Peter F. Bandoske
Service Engineering Operations Manager
Ford Customer Service Division
Emerging Market Services

SUBJECT: DEMONSTRATION / DELIVERY HOLD - Compliance Recall 14C06
Certain 2014 Model Year Transit Connect Vehicles Sold in Puerto Rico
Incorrect Brake Fluid Reservoir Cap Graphics

CERTAIN 2014 MODEL YEAR TRANSIT CONNECT VEHICLES SOLD IN PUERTO RICO — INCORRECT BRAKE FLUID RESERVOIR CAP GRAPHICS

FIGURE 1

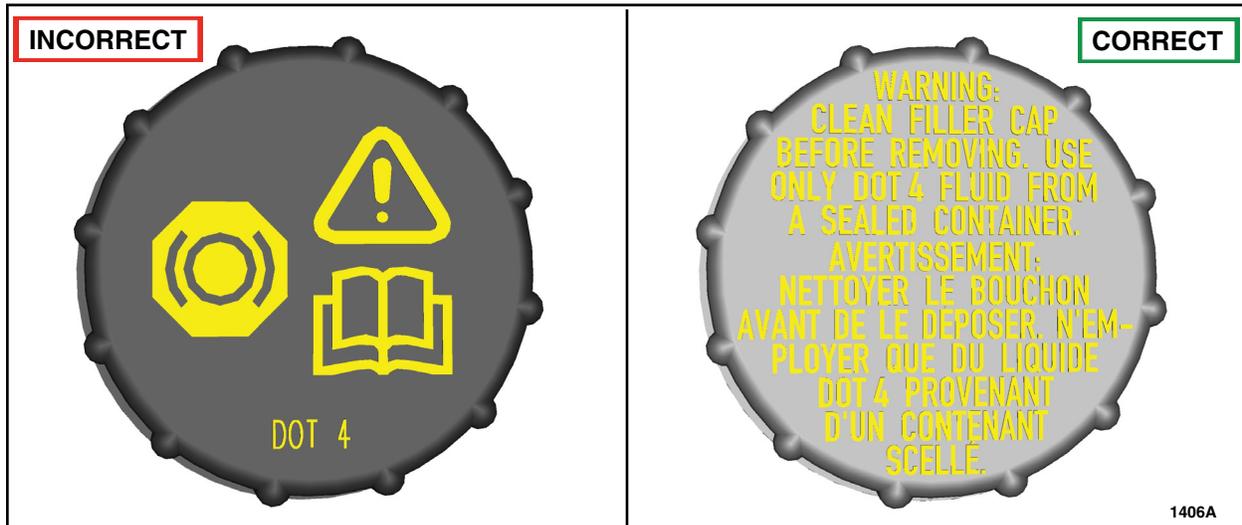
In all the affected vehicles, the brake fluid reservoir cap graphics used for vehicles sold in Puerto Rico do not conform to the requirements specified by U.S. Federal Motor Vehicle Safety Standard (FMVSS) 135 S5.4.3. See Figure 1. Before demonstrating or delivering any of the vehicles involved in this recall, dealers are to replace the brake fluid reservoir cap.

1. Replace the brake fluid reservoir cap:
 - a. Before removing the brake fluid reservoir cap, clean the cap to avoid contamination of the brake fluid reservoir.
 - b. Remove and discard the brake fluid reservoir cap.
 - c. Install a *new* brake fluid reservoir cap.
